DOWNTOWN ALBANY
BUSINESS IMPROVEMENT DISTRICT
21 LODGE STREET
ALBANY, NY 12207

No.	Submittal	Revision	App'd	By	Date
1	ADDENDUM #1		JK	MDA	6/13/18
2	ISSUE FOR BID		JK	MDA	5/23/18

WILLIAM STREET LIGHTING

WILLIAM STREET LIGHTING OPTION A

1 REMOVABLE BOLLARD DETAIL

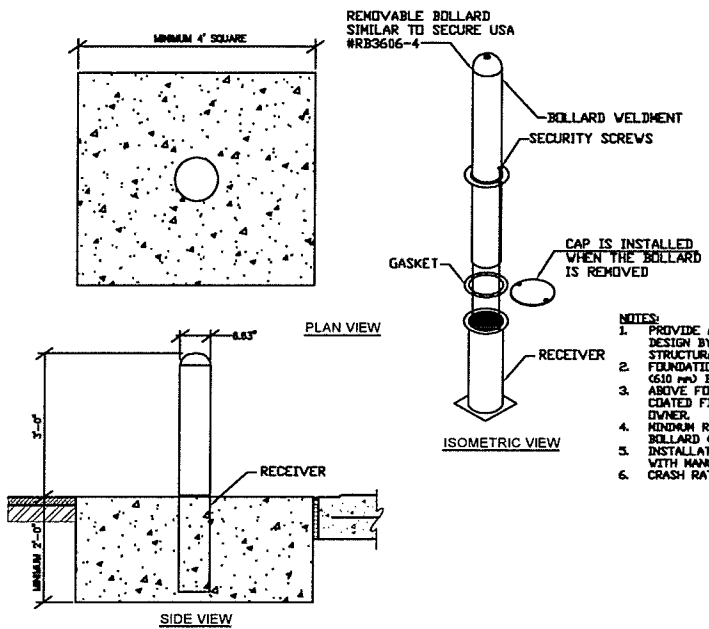
- ROUTE POWER AND CONTROL CONDUITS DOWN COLUMN AND THROUGH CONCRETE WALL. PROVIDE CONDUIT-FITTINGS TO NEW CONDUIT AND DECREASES TO GO TO BELOW GRADE AND INTO POLE BASE.
- UNDER ALTERNATE #2 PROVIDE A SEPARATE PRICE TO REMOVE CONCRETE BOLLARDS AND FOUNDATIONS AND REPLACE WITH REMOVABLE BOLLARDS AS DETAILED ON SKETCH 51-62.
